# Economic and Social Council

### World Forum for Harmonization of Vehicle Regulations

## Proposal for Supplement 1 to the 04 series of amendments to UN Regulation No. 129 (Enhanced Child Restraint systems)

### Revision

**" Annex 6 - Appendix 5  
Optional Dummy Protective Device**

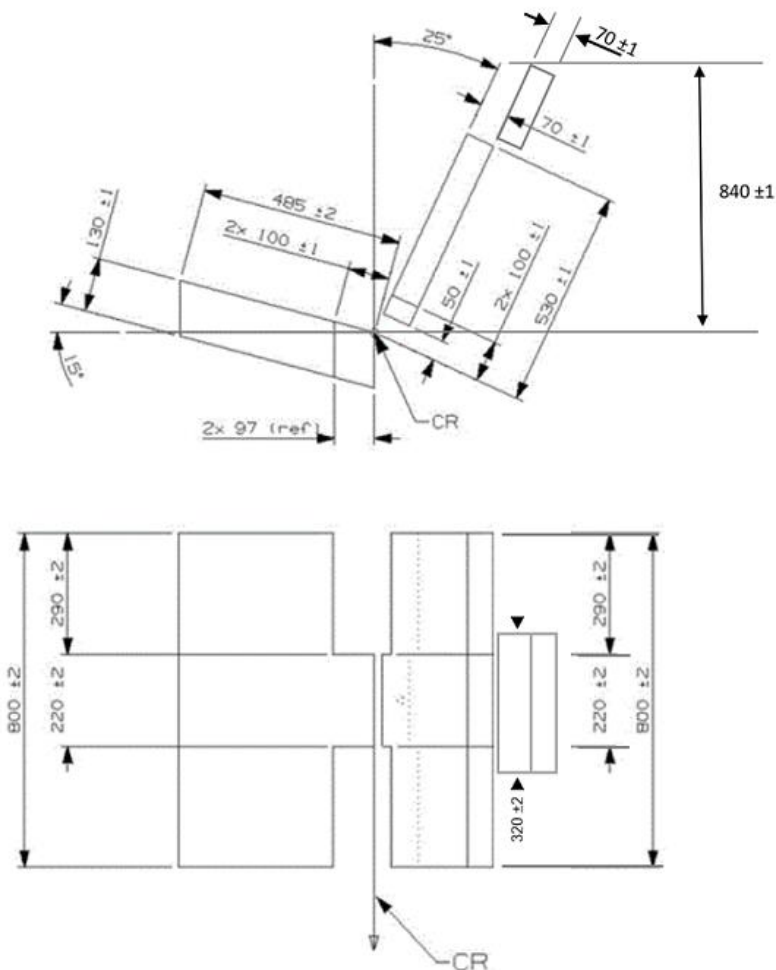
*Annex 6, Insert new paragraphs 3.4., to read:*

"3.4. Optional dummy protective device

An optional dummy protective device may be installed on the test bench for the dynamic frontal test of booster cushion when tested on the test bench described in this Annex.

The dummy protective device may be covered with the Polychloropren foam of the lateral impact door as defined in Appendix 3 of this Annex, or an alternative material, at the decision of the technical service.

The dimensions of the dummy protective device are given in Appendix 3 of this Annex.

The forward face of the dummy protective device shall be parallel with the back of the backrest. The design of the dummy protective device shall be such that it does not interfere with the manikin when positioned on the test bench. Furthermore, the dummy protective device shall not interfere with the dummy and/or the adult 3-point belt during the dynamic test until the maximum horizontal head excursion has been reached.

Insert new Annex 6 – Appendix 5, to read:
